15 December 2021

RE: Response to Submission for Unanderra Liquid Waste Treatment Facility SSD-8304

Figure 2: Project setting and receptor locations

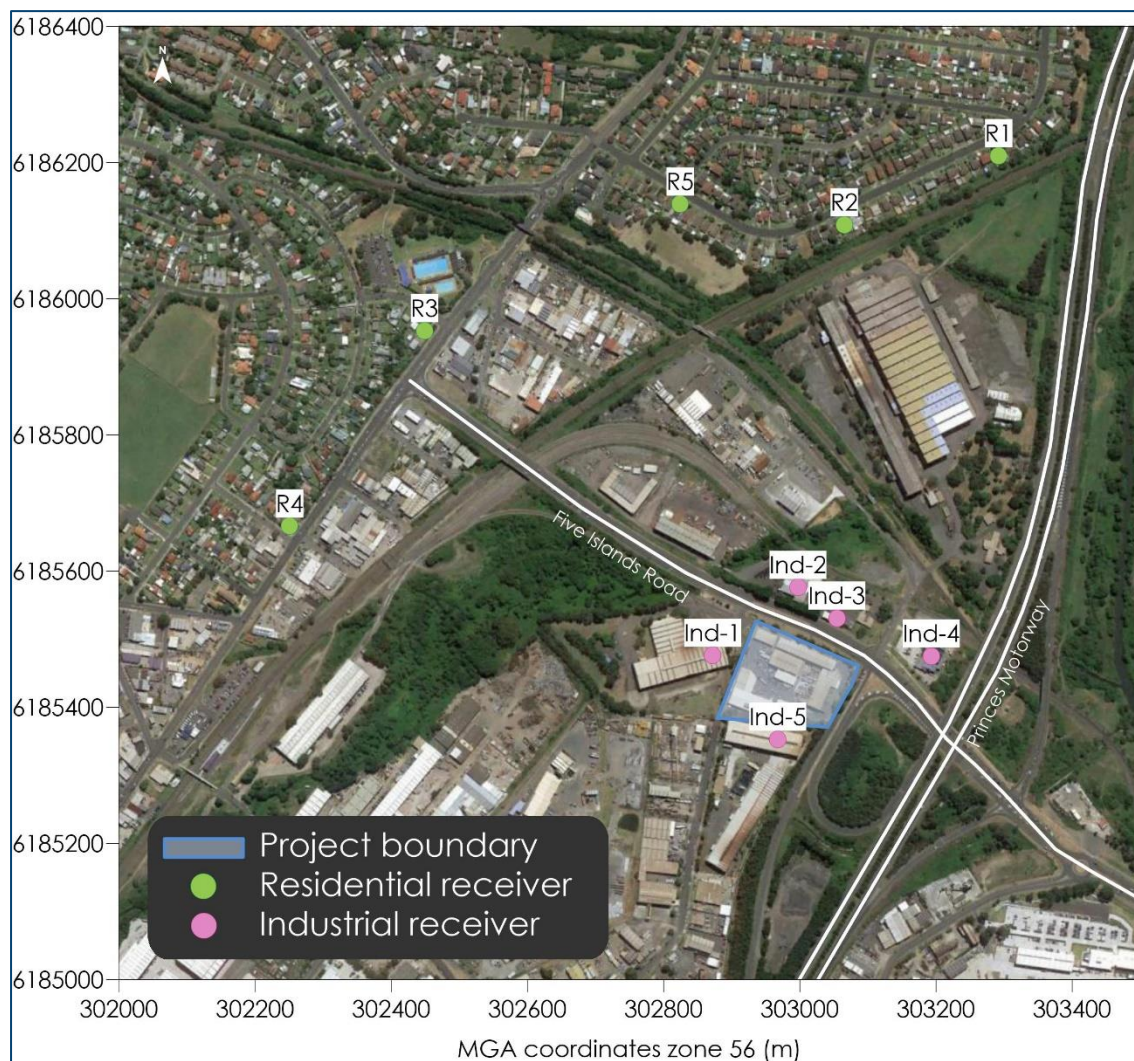
Include relevant information to identify receivers e.g. addresses.

The table of sensitive receivers does not appear to include the Aquatic Centre. Please confirm if this receiver has been assessed. Noting that the current EPL includes a noise limit of 45dBA at the Aquatic Centre.

Table 3 outlines the addresses of the assessed receptors and **Figure 2** presents the location of the Project and the location of selected residential receptors assessed as discrete receptors in the NIA.

The Aquatic Centre located at 1 Marley Place, Unanderra is assessed as Receiver Ind-4 in the NIA. The predicted operational noise impacts presented in Table 6-2 of the NIA indicate a noise level of 45dBA at Ind-4 and indicate it would comply with the noise limits in EPL 5874 for site.

Figure 3: Predicted annual average Pb concentrations ($\mu\text{g}/\text{m}^3$)

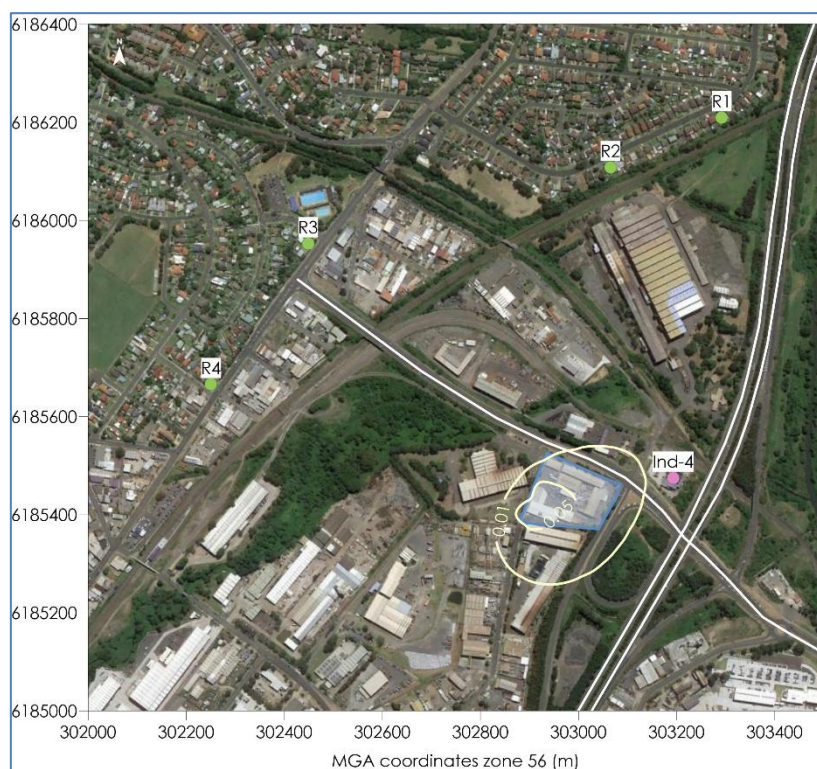
Furthermore, it is noted that Table 7-3 and associated Figure 7-9, lists the impact assessment criterion for lead as 0.5 µg/m³ at 1-hour average, rather than annual. Whilst it is likely a typographical error, and it is recognised that a 1-hour criterion presents a more conservative approach, for complete transparency it should be corrected in the revised assessment.

2) Address identified inconsistencies between the AQIA and Approved Methods for the Modelling and Assessment of Air Pollutants in NSW in regards to correct averaging periods for assessing impacts of lead emissions.

Figure 3 and **Figure 4** present isopleths of the spatial distribution of predicted annual average Pb and 1-hour average H₂SO₄ impacts, respectively.

The results show that minimal incremental effects would arise due to the operation of the Project and the predicted levels would be below the relevant criteria for the assessed pollutants. Predicted levels at Ind-4, (McKeon's Swim Centre), would also be below the relevant criteria for the assessed pollutants.

Figure 4: Predicted maximum 1-hour average H_2SO_4 concentrations ($\mu\text{g}/\text{m}^3$)

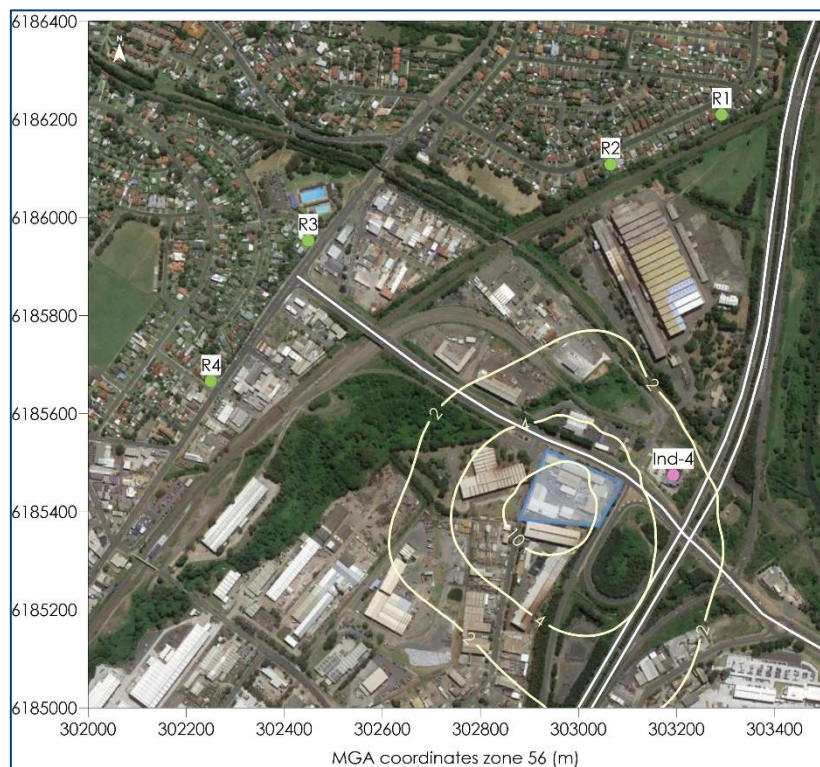
Table 7-3 presents the predicted dispersion modelling results at assessed residential receptor locations. The modelling predicts minor incremental impacts at these locations. However, impacts at the swim-school (McKeon's Swim Centre), located <200m from the site, on the adjacent corner lot (Corner of Marley Place and Five Island Rd Unanderra), were not explicitly provided. Due to the nature of the activities undertaken and materials handled at the DGL premises, EPA considers the swim-school should be recognised as a community sensitive receptor and tabulated impacts at this receptor be provided.

1) Consider potential for ground level impacts at the swim-school (McKeon's Swim Centre) located on the corner of Marley Place and Five Island Rd, Unanderra.
